YPEA AMD 01/23

This amendment replaces YPEA AMD 04/22.

1 Taxi Route Diagrams

Figure 4.2.1 - Departure Taxi Routes

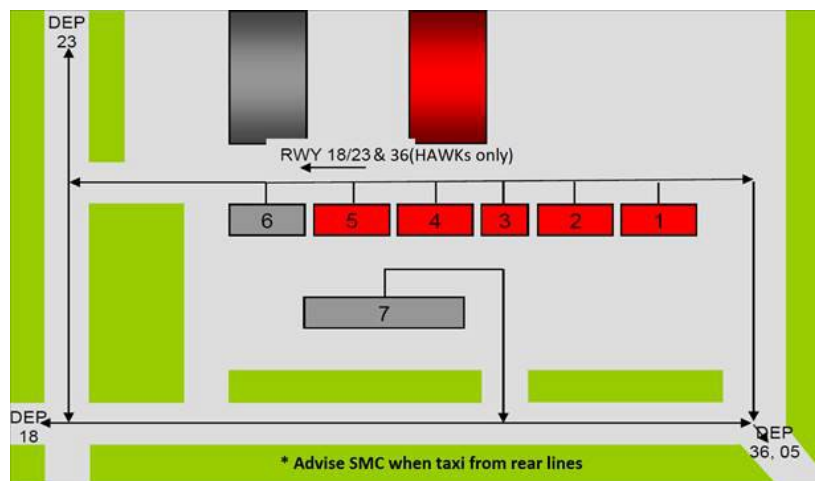
After consultation with the affected flying squadrons some minor discrepancies were identified in the taxi diagrams depicted in FIHA AD2 Supplement Pearce.

FIHA AD2 Supplement Pearce 4.2.1 Figures 4.2.1 and 4.2.2 are now the following;
